UNITED STATES PATENT AND TRADEMARK OFFICE

APPLICATION NO.	FILING DATE	FIRST NAMED INVENTOR	ATTORNEY DOCKET NO.	CONFIRMATION NO.
10/595,612	05/01/2006	Timothy George Bissett	UDL-174	3548

Office Action Summary	Application No. 10/595,612	Applicant(s) BISSETT, TIMOTHY GEORGE	
	Examiner DANIEL CAHN	Art Unit 3634

DETAILED ACTION

5,316,102

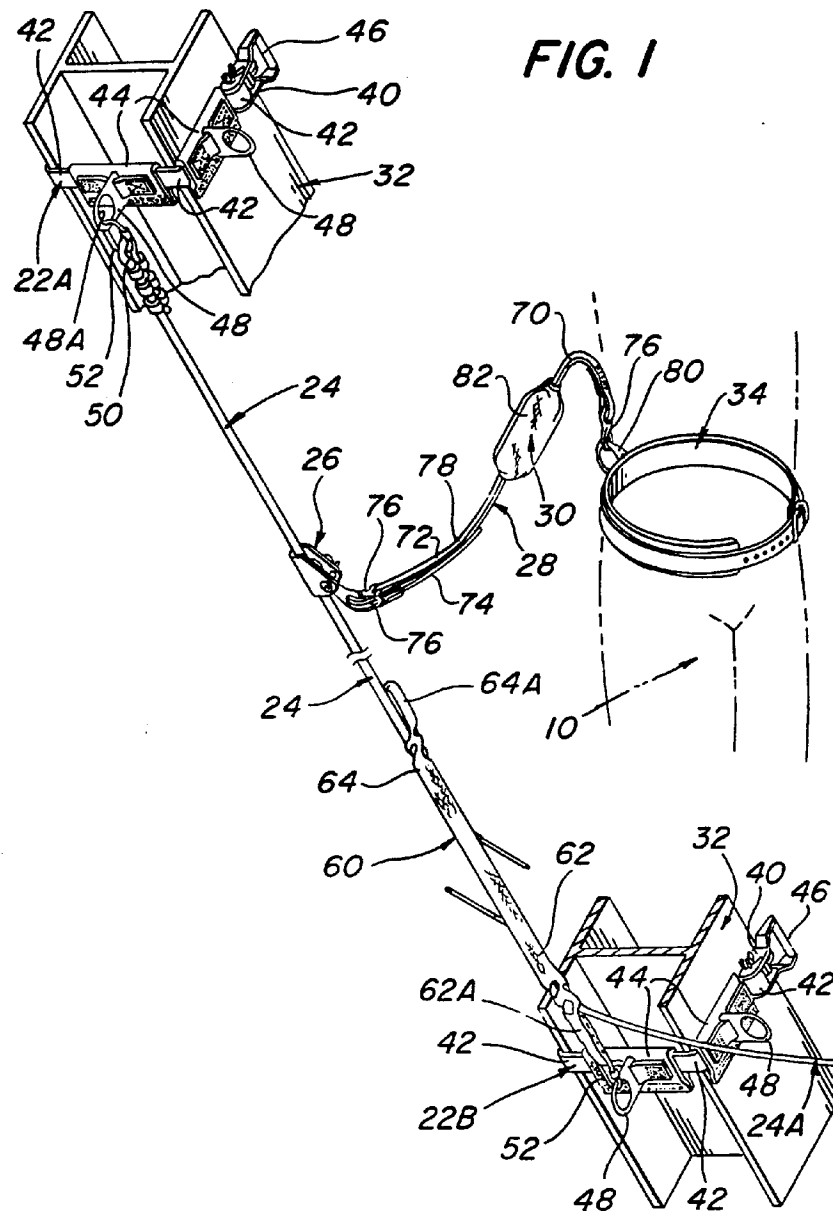
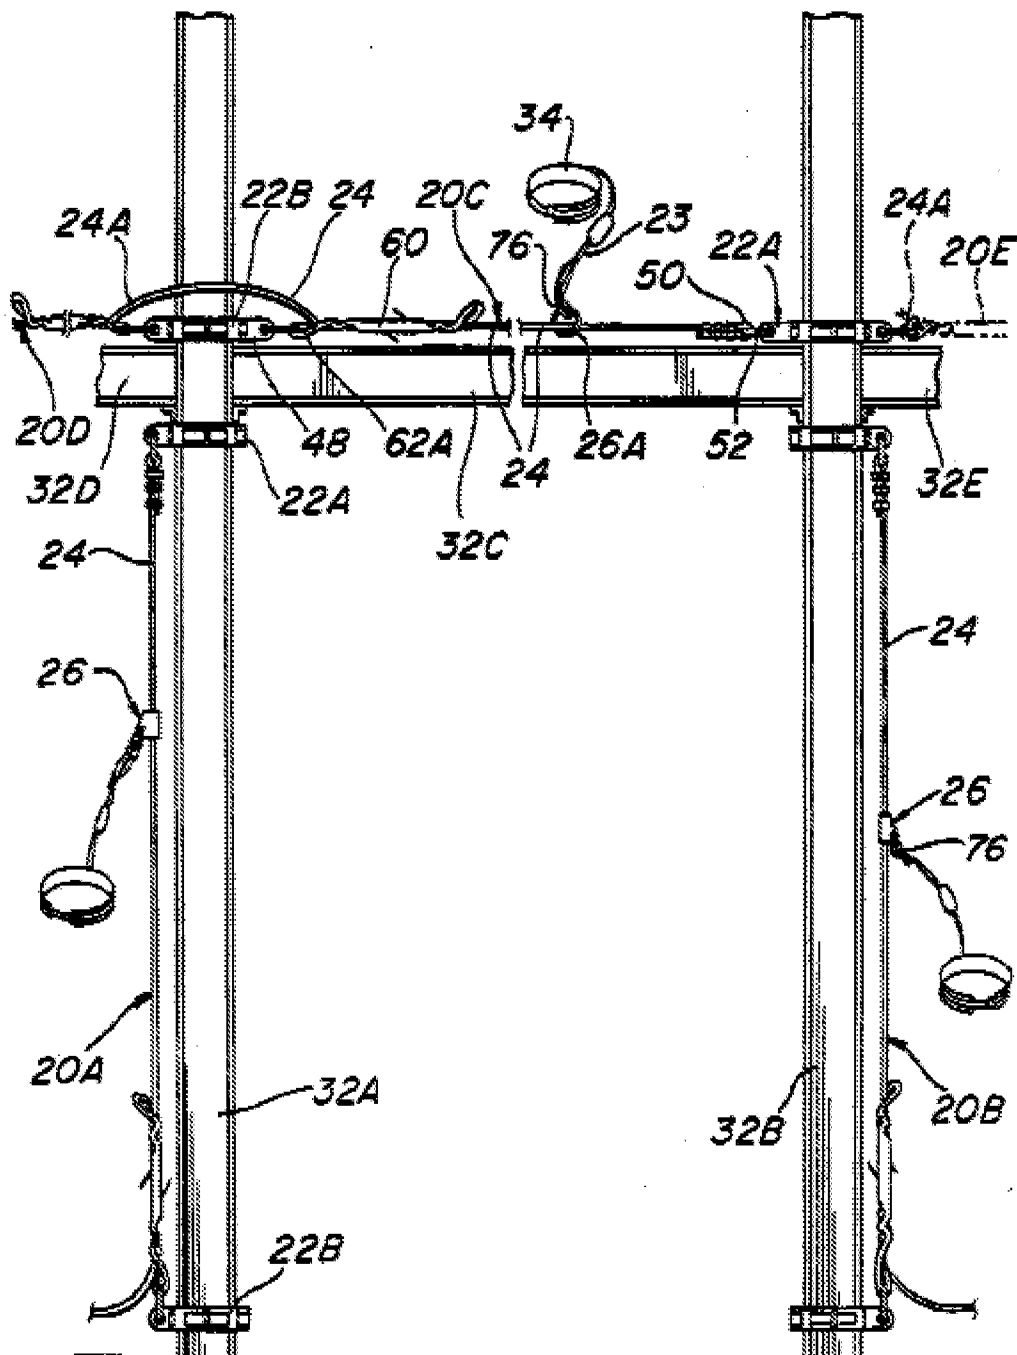
Claims 16, 17, 19-23 and 28 are rejected under 35 U.S.C. 102(b) as being anticipated by Bell (US 5316102); or in the alternative under 35 U.S.C. 103(a) as being unpatentable over Bell '102.

Regarding claims 16, 17 and 28, Bell teaches:

A fall arrest system (depicted in Fig. 1) **for use with a fall arrest device, the fall arrest system comprising:**

an upper anchor point (22A except for the D-rings 48; Fig. 1) **secured in a fixed position;**

a first energy absorbing means (D-ring; 48A) **coupled to said upper anchor point** (examiner notes that the definition of the term 'absorb' has been provided below, and that any element which takes in, endures, or consumes energy can be reasonably interpreted as an 'energy absorbing means');

a lower anchor point (22B except for the D rings 48; Fig. 1) secured in a fixed position vertically below said upper anchor point and said first energy absorbing means; and

a cable (24; fig. 1) extending vertically between said first energy absorbing means and said lower anchor point, wherein said upper anchor point and said lower anchor point exert opposed tensile forces that are imparted on said cable extending between said first energy absorbing means and said lower anchor point such that said cable is pre-tensioned (examiner notes that the anchor points can be adjusted in height and therefor inherently provide the ability to pretension the cable depending on far apart they are anchored from each other); **and**

'a second energy absorbing means from claim 28' (the D-ring 28 connected to 22B; see Fig. 1) coupled to and operably disposed adjacent said lower anchor point and connected to said cable,

'a second energy absorbing means from claim 17' (26, 30, 80; Fig. 1) configured to couple [capable of coupling] to the fall arrest device (such as a harness 34) and control a load applied to a user during said fall arrest event.

wherein said first energy absorbing means and said second energy absorbing means are connected to said cable and control (or direct, regulate, operate, etc.; the D-ring control a shock since they direct the shock towards the anchors) a shock load applied to said upper anchor point resulting from forces applied by the fall arrest device to said cable during a fall arrest event.

said cable has an upper end and a lower end, said upper anchor point is operably disposed at said upper end, and said lower anchor point is operably disposed at said lower end (as depicted in Fig 1).

22. (previously presented) A fall arrest system according to claim 16, further comprising: at least one cable guide. Since this claim is solely dependt from claim 16, the cable guide can be interpreted as element 26 (which is not needed for claim 16, it is only used in claim 17) or the guide could be considered element 60 or the lower D-ring, or etc.

a third energy absorbing means (since this depends from claim 16 which has not yet claimed a second energy absorbing means, the lower D-ring 48 or element 26 could be considered the “third” energy absorbing means) **coupled to and operably disposed adjacent said lower anchor point and connected to said cable** (such as the D-ring; depicted in Fig. 1), **wherein said third energy absorbing means also controls said shock load applied to said upper anchor point** (by directing some of the force to the lower anchor point, the lower D-ring controls the load applied to to the top anchor point by lowering the force applied to it as a result) **resulting from forces applied by the fall arrest device to said cable during said fall arrest event.**

No. 204,581.

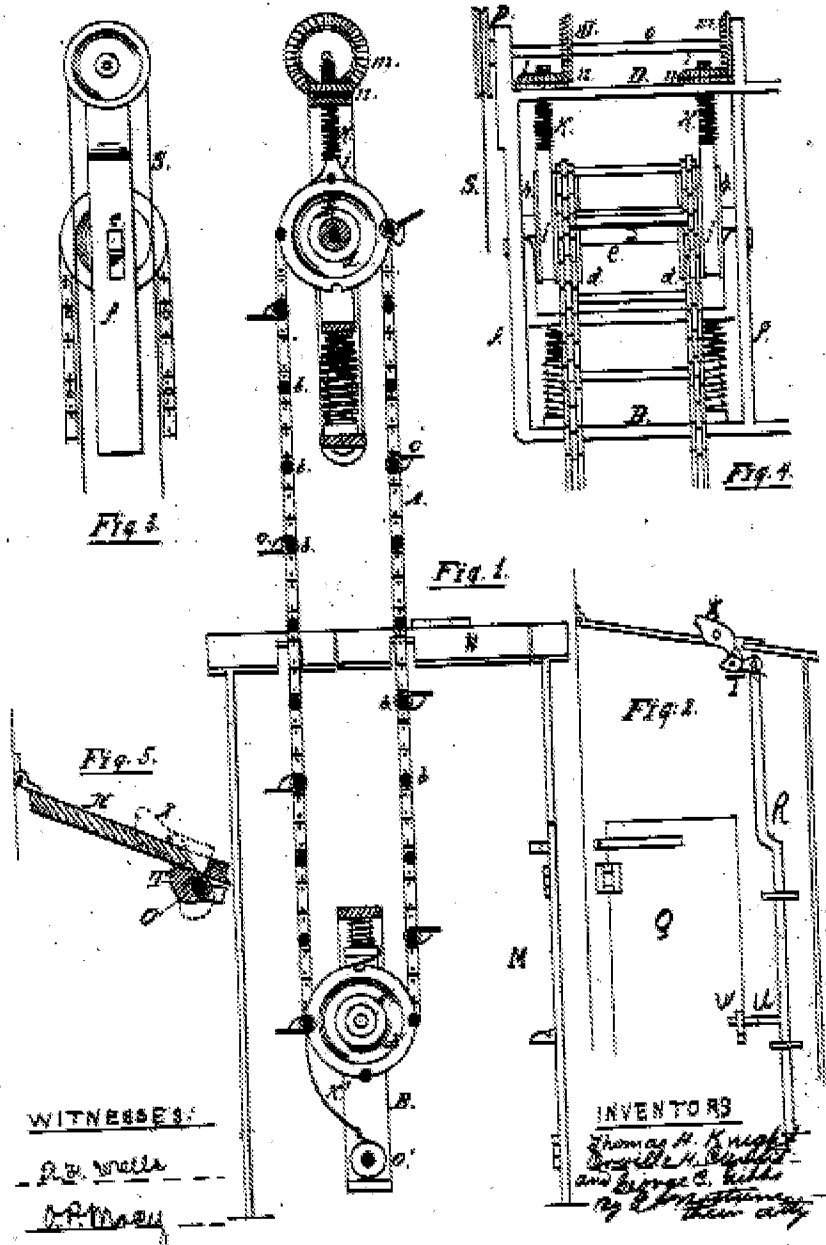
Claims 24, 25, 27 and 29 are rejected under 35 U.S.C. 103(a) as being unpatentable over Bell (US 5316102) as applied to claim 16 discussed above, and further in view of Knight et al. (US 204581).

Regarding claims 24, 25, 27 and 29, all of the elements of the instant invention are discussed in detail above except providing the fall arrest system according to claim 16 or 28 with said first energy absorbing means as being resilient, or as being a spring, or as being capable of absorbing standing waves forces. Therefore, attention is directed toward Knight which teaches a similar safety user ascent/descent system (ladder escape device as depicted in Fig. 1) having a wire cable (**A; Fig. 1**) being pre-tensioned (via the springs; as depicted in Fig. 1) where the wire cable is anchored at its top via spring (**K, Fig. 1**) and anchored at its bottom via a spring (**as depicted in Fig. 1**).

5,799,760

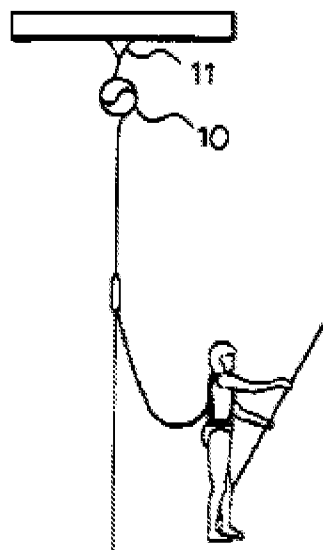
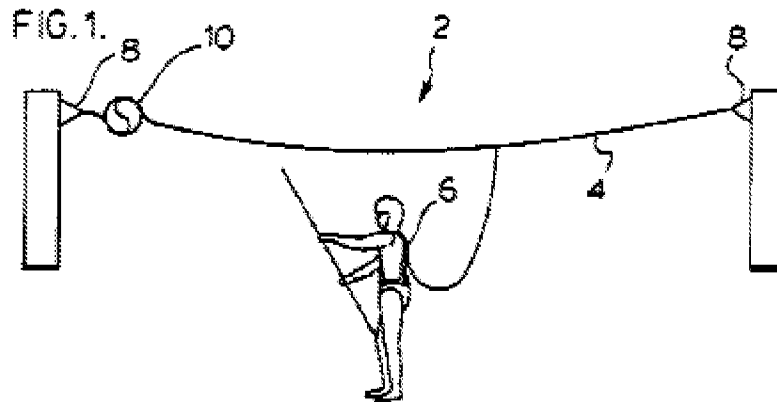
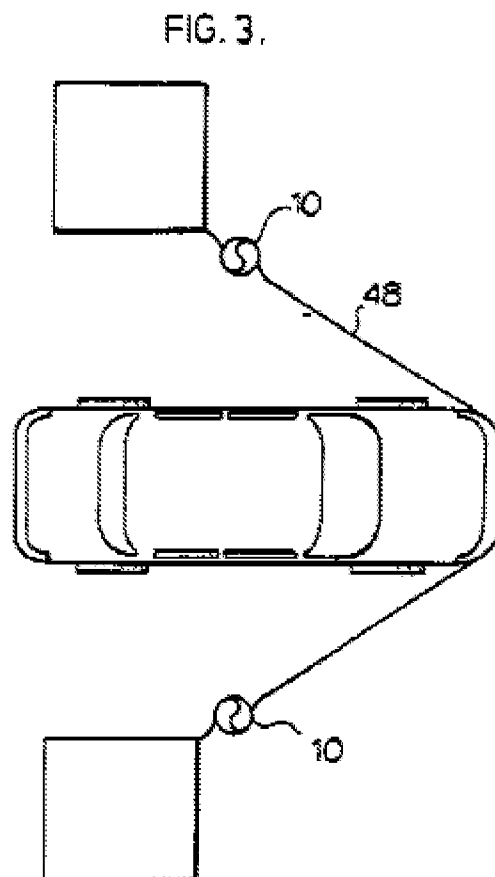
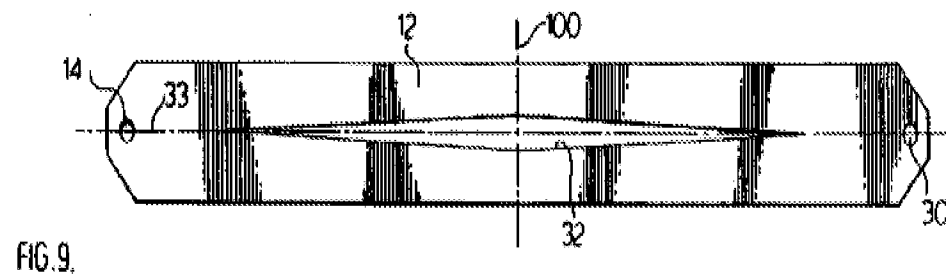
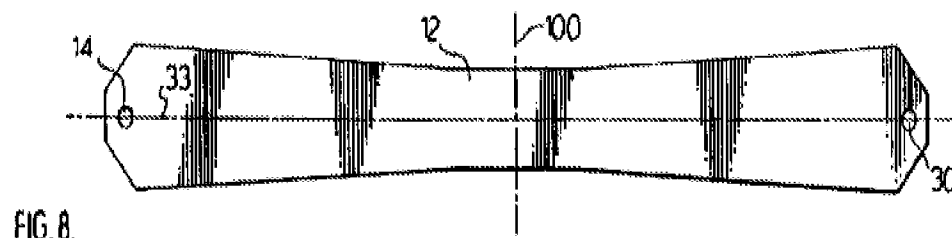
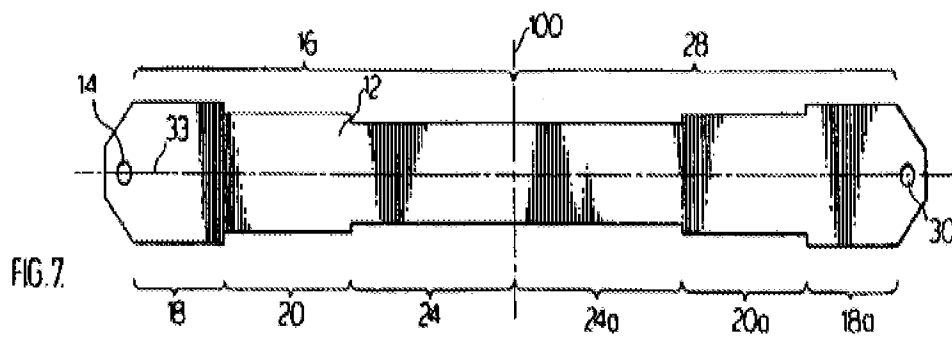
Claims 26 and 30 are rejected under 35 U.S.C. 103(a) as being unpatentable over Bell (US 5316102) as applied to claim 16 discussed above, and further in view of Small (US 5799760).

Regarding claims 26 and 30, all of the elements of the instant invention are discussed in detail above except providing the fall arrest system according to claim 16 or 28 with a plastically deformable element as the energy absorbing means. Therefore, attention is directed toward Small which teaches a similar fall arrest device (see Fig. 1 and 2) in which a cable/track (4) is anchored to an anchor point (at 11; Fig. 2) via a plastically deformable shock absorbing means (10).

All of the elements of the instant invention are discussed in detail above except providing that said first energy absorbing means comprises a plastically deformable wound coil element configured to unwind [capable of unwinding] and extend in plastic deformation when deployed to absorb energy and control a shock load applied to said upper anchor point resulting from forces applied by the fall arrest device to said cable during a fall arrest event. Therefore, attention is directed toward Small which teaches a similar fall arrest device (see Fig. 1 and 2) in which a cable/track (4) is anchored to an anchor point (at 11; Fig. 2) via a plastically deformable shock absorbing means (10).
